DEPARTMENT OF TRANSPORTATION**National Highway Traffic Safety Administration****49 CFR Part 571**

Federal Motor Vehicle Safety Standards; Ejection Mitigation**AGENCY:** National Highway Traffic Safety Administration (NHTSA), Department of Transportation.**ACTION:** Final rule; response to petitions for reconsideration.

SUMMARY: This document responds to petitions for reconsideration of a 2011 final rule that established Federal Motor Vehicle Safety Standard (FMVSS) No. 226, “Ejection mitigation.” The standard is intended to reduce complete and partial ejections of vehicle occupants through side windows in crashes, particularly rollover crashes. Generally, the issues raised by the petitioners are of two types. The petitioners ask for reconsideration of policy issues relating to the agency’s implementation of the standard, and of technical issues concerning engineering aspects of the rule, particularly as to how the compliance test procedure should be conducted or improved. Most of the requested changes were of the latter type. In general, NHTSA is denying the petitions for reconsideration. The few changes we have made in response to the petitions are minor, mostly to clarify the r

Figure 1 – Effect of a Grab Handle on the Target Locations of a 1st Row Window

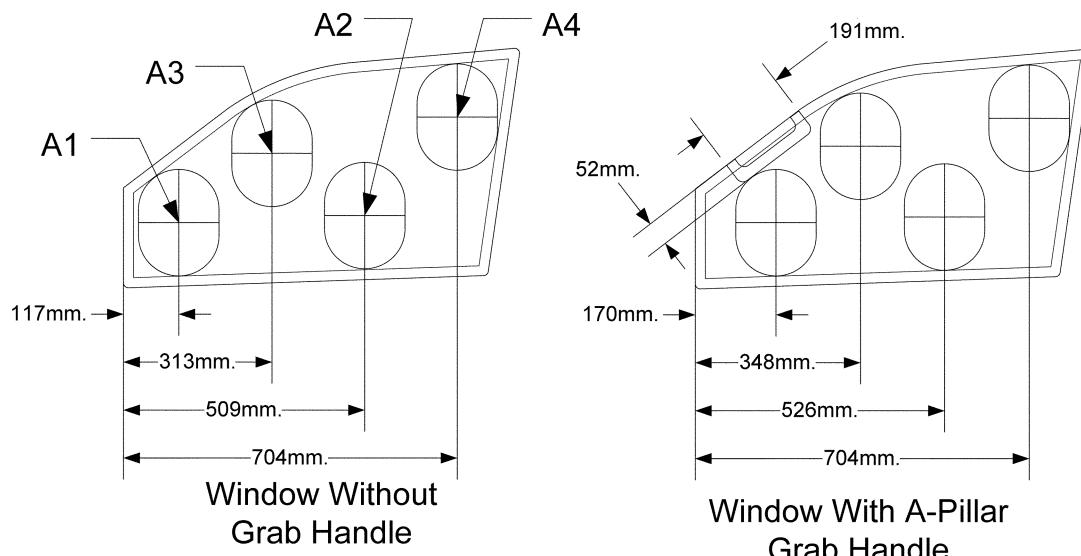
In its petition for reconsideration, the Alliance disagrees with the agency's decision in S6.3 to remove or adjust grab handles. The petitioner states that grab handles located inboard of the air bag deployment path are commonly attached through the headliner or A-pillar garnish trim to the vehicle structure. The petitioner states:

"Removing these handles can change the headliner and trim attachment structure and bending characteristics. Changing the bending characteristics of the headliner can lead to curtain airbags [sic] not deploying as

designed and there could be unintended interactions with the testing device." The Alliance also states that, for handles located outboard of the air bag deployment path, the grab handles may also function as a reaction surface for curtain air bags. "If the handles were to be removed, the deployment characteristics and reaction surface of the airbag [sic] would be changed from the design intent. In addition, the surface of the pillar would be changed, which could lead to exposed mounting brackets and rough surfaces that can lead to tearing of the airbag [sic] and/or a change of the deployment characteristics."

real world. For grab handles, we have determined there is reason to remove the component (and the other items listed in S6.3) due to potential interference with the impactor. However, we concur that the grab handle should be removed with minimal disturbance to the trim.

Figure 2 – Graphic provided by ASC, showing a daylight opening with no top right-hand corner

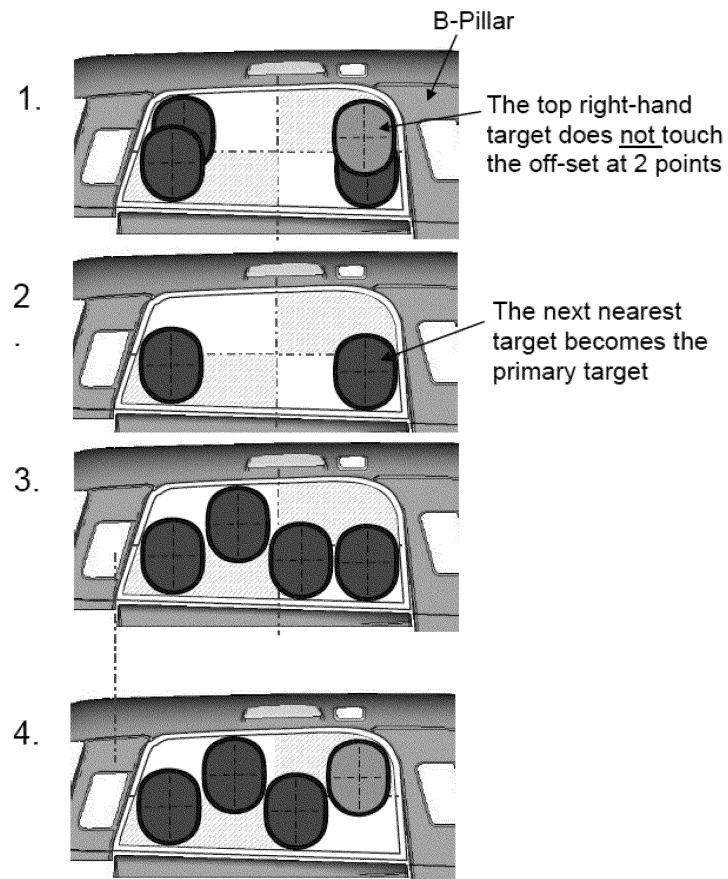
ASC asks for clarification of the targeting procedure for a window opening with a large radius, regarding the forward-upper quadrant of the daylight opening. It asks how NHTSA will position a target at the “corner” location(s) for this area of the window (top image (labeled “1”) in Figure 2, below.). ASC states that if the procedure is followed as written, the target would only contact the daylight opening offset-line at one point and, therefore, this quadrant would not contain a target. ASC states that S5.2.3.3 then specifies that the forward lower target would become the new primary target (image labeled “2” in Figure 2). ASC states that continuing with the specified test procedure, the selected targets would be as illustrated in the image labeled “3” in Figure 2. ASC believes that NHTSA intended the targets to appear as shown in the image labeled “4” rather than image 3 and asks for clarification of the procedure to achieve the target layout shown in image 4.

ASC is correct that the procedure of S5.2.3 results in the layout shown in image 3 in Figure 2. However, it was not our intent that the test procedure must specify placement of a target in the forward-upper quadrant of the window opening no matter the shape of the daylight opening. We believe that the absence of a corner in the forward-upper quadrant is not typical, so the final placement of the targets in the example shown is also not typical. NHTSA has not encountered a situation like this in any vehicle we tested.

Figure 4 (Figure “5b” in regulatory text)

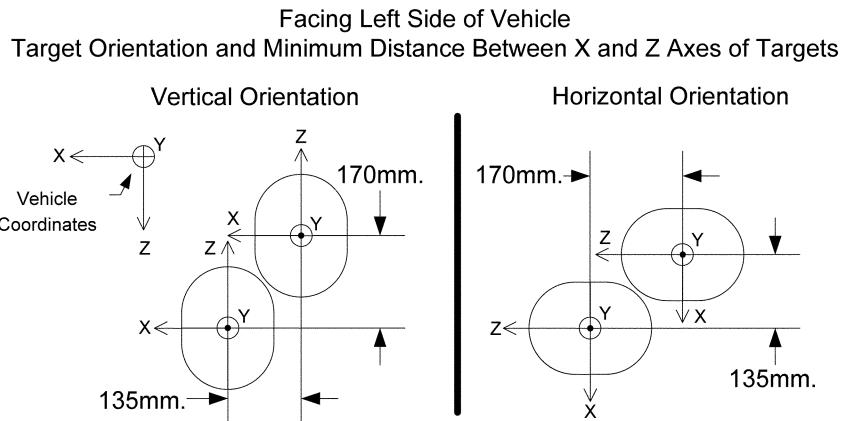
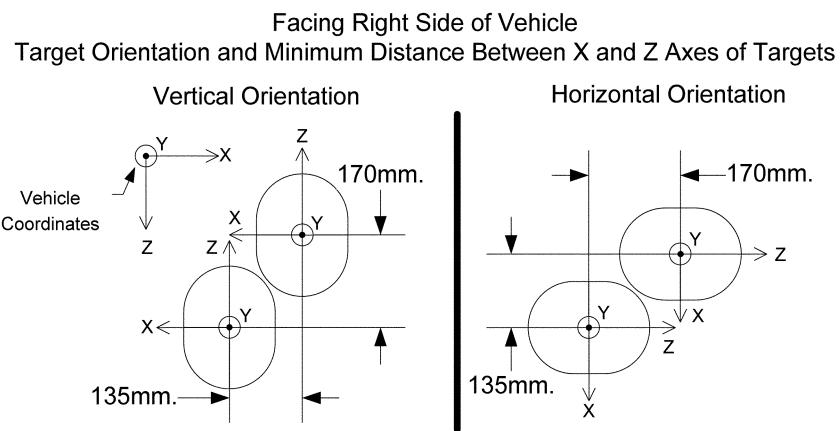
The Alliance believes that the reference coordinate axes used throughout the regulation, and particularly in S5.2, need illustrations and/or figures to better define the vehicle, headform and target axes, especially with rotation of the headform. TRW and ASC ask for clarification of S5.2.5.1.1 as to the specified distances between the target's local z-axis and x-axis, i.e., whether the distances remain constant irrespective of target orientation. Both the Alliance and ASC provide figures to illustrate their understanding of S5.2.5.1.1 and S5.2.5.2 and ask if their understanding is correct. They suggest that figures be added to the regulatory text to help clarify the relationship between vehicle and target axes when assessing possible target elimination.

We are granting this request. The figures submitted by the Alliance, TRW and ASC correctly interpret the regulatory text in S5.2.5.1.1. We agree that adding figures to the regulatory text would be helpful. We are adding the figures below to the regulatory text as new Figures 5a and 5b. Figure 3 below (new Figure 5a in the regulatory text) shows the vehicle and target coordinate systems from the perspective of a viewer facing the left side of the vehicle exterior. The minimum distance of 170 mm and 135 mm between the x and z axes, respectively, are also shown. The left side of the figure shows these minimum distances for vertically-oriented targets and the right side of the figure shows these for horizontally-oriented targets. Additionally, the right side of the figure provides the orientation of the z axis of the target specified in S5.2.5.2.

Figure 4 below (new Figure 5b in the regulatory text) shows the vehicle and target coordinate systems from the perspective of a viewer facing the right side of the vehicle exterior.

A reference to these new figures will be made in S5.2.5.1.1 and S5.2.5.2. Also, a typographical error is corrected in S5.2.5.1.1. The Alliance has noted that in the fourth sentence of S5.2.5.1.1, “y axis” is incorrectly referenced. The correct reference is “x axis.”

Figure 6 – Maximum overlap of targets under various scenarios

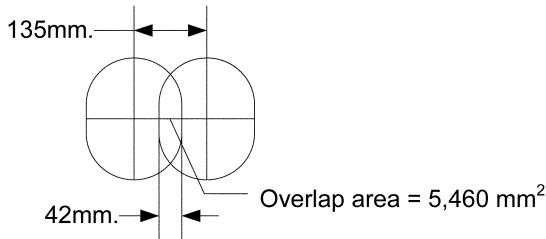
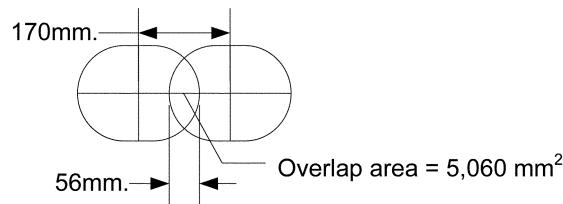
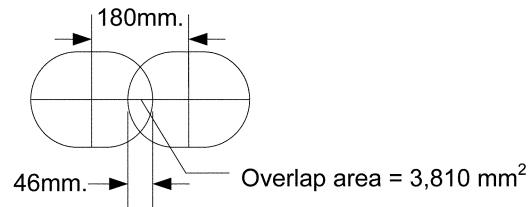
Example 3 is the situation for which ASC suggests the agency should make some form of accommodation to reduce the potential overlap. However, we see that, when compared to Examples 1 and 2, Example 3 has a smaller area of overlap than Examples 1 or 2 and less linear overlap than Example 2. The maximum potential overlap under S5.2.5.1.2 for horizontal targets is, in fact, less than the maximum potential target overlap for other target configurations. All-in-all, we do not believe that these targeting scenarios allow for excessive overlap. The targeting procedures ensure that the ejection mitigation countermeasure is evaluated throughout coverage of the daylight opening. Accordingly, because we do not believe the overlap allowed for horizontal targets by S5.2.5.1.2 is excessive, we see no reason to limit it further.

We decline to increase the 360 mm distance for horizontally-oriented targets.³² There is a potential for three horizontal targets to represent the final target locations under provisions of S5.2.5.2. The question presented is whether the overlap of the horizontal targets is excessive compared to the overlap “permitted” by the standard for vertical targeting configurations. To help in this assessment we have constructed Figure 6, below. This figure shows the maximum allowable overlap of targets under three different scenarios.

another. In the three scenarios of Figure 6, the horizontal axes are aligned. Example 1 shows the maximum overlap for vertically-oriented targets under the provision of S5.2.5.1.1.³³ The linear overlap of these targets is 42 mm and the area of overlap is 5,460 mm². Example 2 shows the maximum overlap for horizontally-oriented targets under the provision of S5.2.5.1.1. The linear overlap of these targets is 56 mm and the area of overlap is 5,060 mm². Example 3 shows the maximum overlap for horizontal targets under the provision of S5.2.5.1.2.³⁴ The linear

overlap of these targets is 46 mm and the area of overlap is 3,810 mm².

Figure 7
(Showing Figure 16 in NPRM)

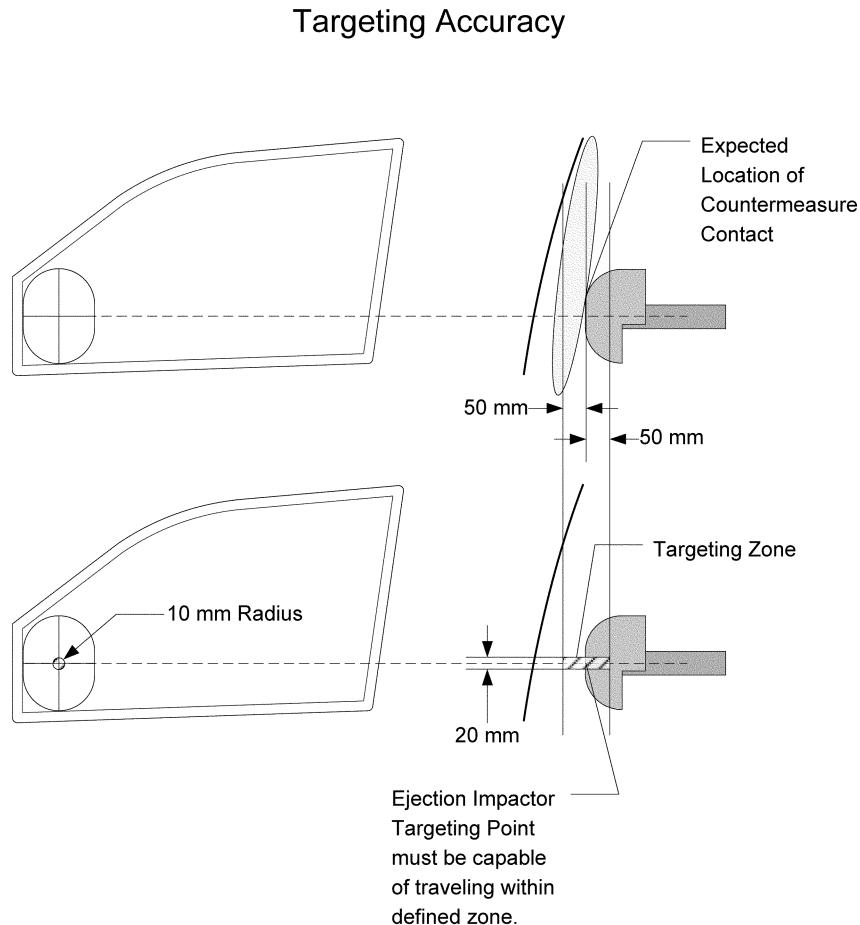
As shown in Figure 16, a zone could be established by first determining the "ejection impactor targeting point," the intersection of the x- and y-axes on the outer surface of the headform. Next, the location of first contact between the impactor and the ejection mitigation countermeasure (e.g., ejection mitigation air bag curtain) would be determined, based on the location of the target outlines using the methodology in the compliance test specified for identifying the target outlines. A 100 mm wide zone would be determined by defining two vertical longitudinal planes that are 50 mm on either side of the expected location of contact by the impactor with the countermeasure. These longitudinal planes define a portion of the strike zone. The other portion of the zone would be defined by locating the axis normal to and passing through the target outline center. As the impactor targeting point passes at test speed through the 100 mm wide zone (as it passes "over the plate," using the baseball analogy), it must stay within ± 10 mm of the axis passing through the center of the target outline center (continuing the analogy, it must stay within the vertical zone bounded by the batter's knees and chest). This assessment would not be conducted with an ejection mitigation air bag curtain

We are granting the request to revise S7.4. The Alliance is correct that the zone specified in S7.4 is a cylinder with a 10 mm radius. However, “D” does not represent the line segment that the cylinder is centered around. Rather, “D” was intended to be a point of reference for the theoretical point of contact with the countermeasure. In response to the Alliance’s comment that vertical and longitudinal planes cannot be defined in vehicle coordinates as forward and rearward of a lateral segment, the terms

After reading the Alliance’s petition, we have revised S7.4 solely for purposes of clarifying it. No substantive change is intended. Among other things, we have rewritten S7.4 to indicate the cylindrical nature of the zone of interest and to eliminate the reference to distance “D,” since the reference to D was confusing to the petitioner.
